SP-17-00192: A site plan for the construction of two new Greek houses [ZBT Fraternity House] and Pi Kappa Phi Fraternity House] on one lot located in the 1500 block of Sigma Nu Place. Submitted by Lantz1505, LLC, property owner of record.

ADMINISTRATIVE DETERMINATION: The Planning Director approves the above-described Site Plan.

Figure 5: Patio Screening

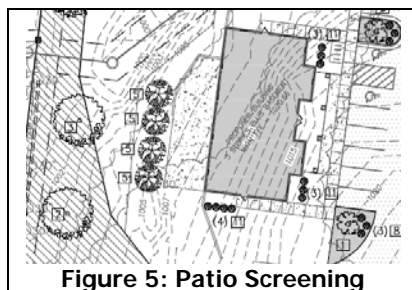
The west side of the property is dedicated to detention for the site with a large retaining wall as well as a continuous 6' high fence that screens the parking lot and buildings at the north end. The south building includes an outdoor patio. The patio area is screened with additional evergreen trees

that provide an added layer of screening to the existing vegetation in the southwest corner of the site.

Figure 4: Development Setback

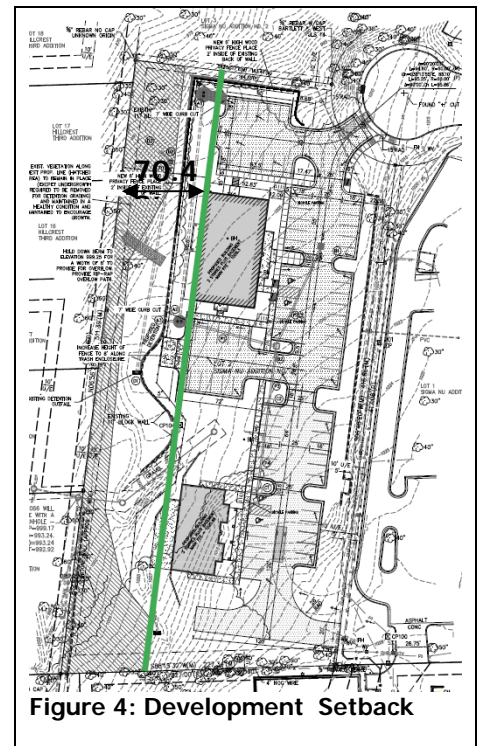
The minimum buffer yard width is 10 feet. The proposed buildings and parking lot are setback more than 70' from the west property line (abutting the detached dwellings lots to the west). This setback creates an extraordinary buffer yard. It is more than twice the maximum 25' buffer yard width identified in section 20-1005 (d).

Figure 7: Existing Vegetation to be Preserved along West Property Line

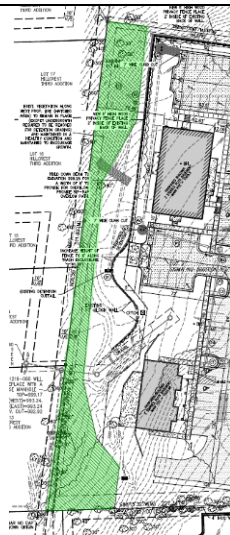
The southwest corner of the property is encumbered by dense vegetation. The applicant's intent is to maintain and preserve as much of the vegetation as possible. A note has been added to the face of the landscape plan that areas that will not be impacted by grading will be maintained.

Table 5: Building Elevations

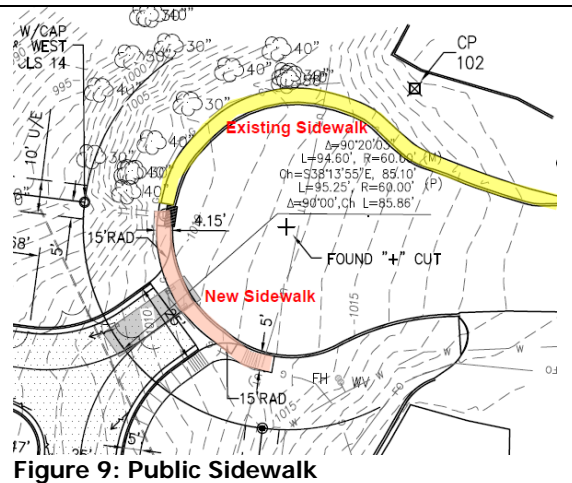
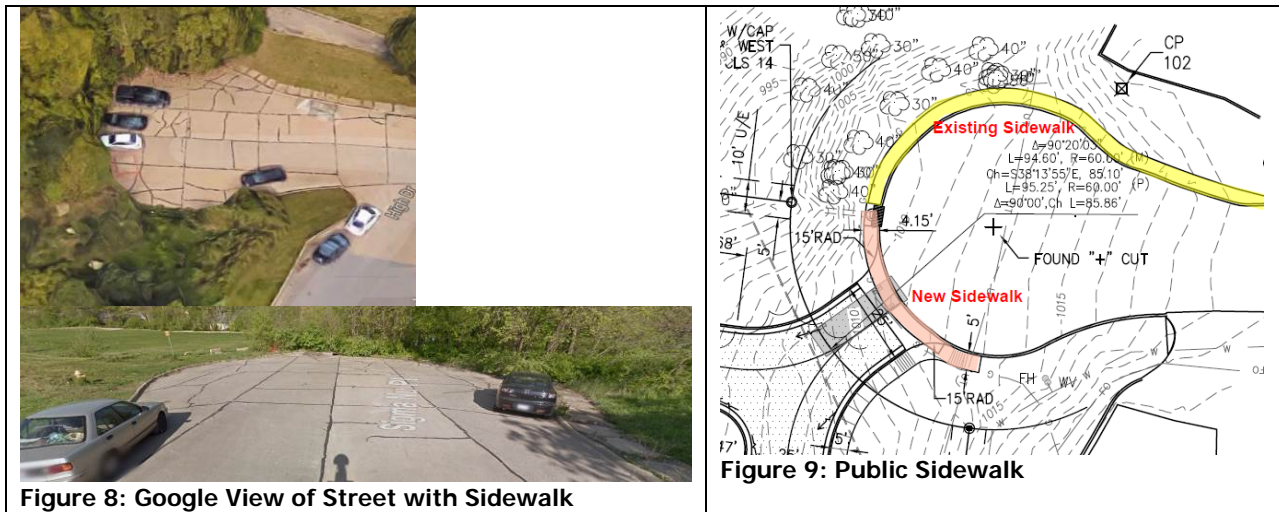
Building Height. The RMG district allows a maximum building height of 35'. The proposed plans indicate that both buildings will include three floors and a basement. The building elevation shows both buildings comply with the maximum building height of the district at 34'-9^{1/8}". Care will need to be taken to ensure that the building height is maintained during construction.

The building height is measured to the "average height of the highest gable of a pitched or hipped roof and the ridge of the roof". Both buildings are proposed as three story buildings with basements. The building permit for the south building shows the height as 34'-3^{7/8}".

The building profile for the north building is the same as the front and does not include a walkout basement. It will appear as a 3-story building from both the front and rear of the building. The south building includes a walkout basement such that the building will appear as 4-stories from the rear.
